Architectural Review Board

SUBJECT: New Business – Item 7
15 W. Stong St
NHPD / PC-1
New Construction

Covington Place
15 West Strong Street
Pensacola, FL 32501

| ARCHITECT'S SEAL ARCHITECTURAL SITE PLAN | |

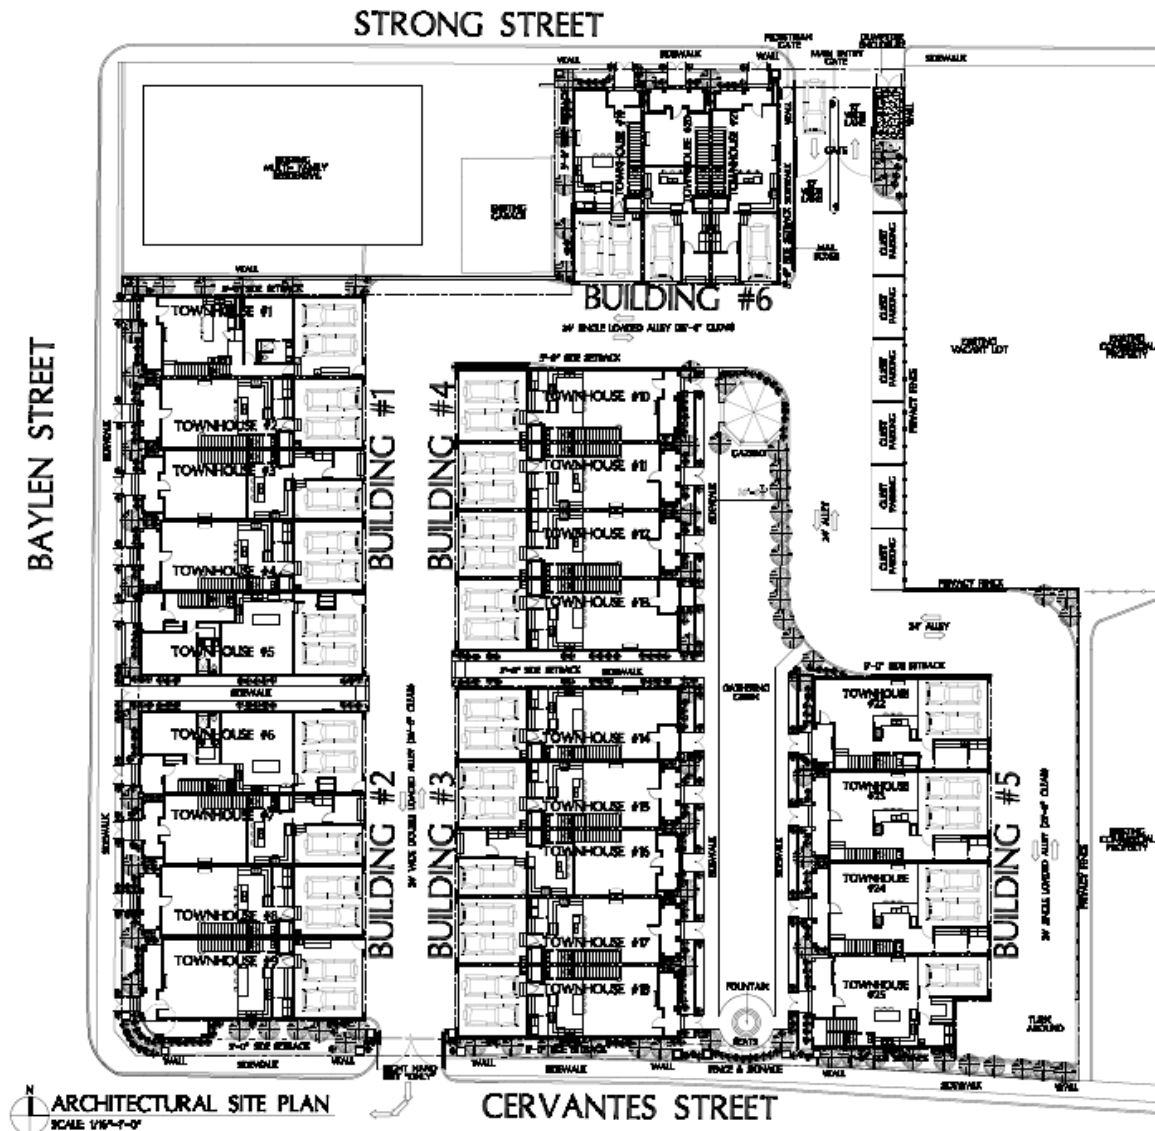
Mr. Townes addressed the Cervantes elevation. Mr. Kunze advised he tried to make the gables more inviting. Wrought iron gates will be built on the Cervantes side at the driveway exit and entrance to the green, which will have some type of fountain. Mr. Townes was concerned with Buildings 9 and 18 being flat and unadorned. He suggested anything to differentiate the building line on the Cervantes Street side, possibly pulling it in and making it smaller. Mr. Mead asked if they were considering block panels with brick piers or pilasters for the wall gates. He advised at least two gables on the larger buildings along Cervantes would help. Mr. Kunze was agreeable to those suggestions. Mr. Jones agreed that Cervantes would be very visually prominent to the community.

Mr. Mead made a motion to approve the plan with the following changes: an addition of a south facing gable for the Cervantes façade on the western most and central building ends facing Cervantes (townhouse 9 & 18); approval of the fence with brick piers and appropriate stone caps with block or brick with some manner of planting to green the wall with ivy or appropriate vines. Ms. Campbell seconded the motion. Chairman Quina asked if the block was skim coated, and Mr. Mead clarified it would be skim coated. Mr. Jones asked about the brick pavers, and Mr. Liberis stated the actual sidewalks would be concrete, the steps and porch floor of the first floor would be brick veneer, but there could be a brick edge between the sidewalk and the front step. Also, the driveways between the units would be asphalt. Chairman Quina thanked the applicant for being transparent with the neighborhood and having a preliminary review. The motion then carried unanimously.
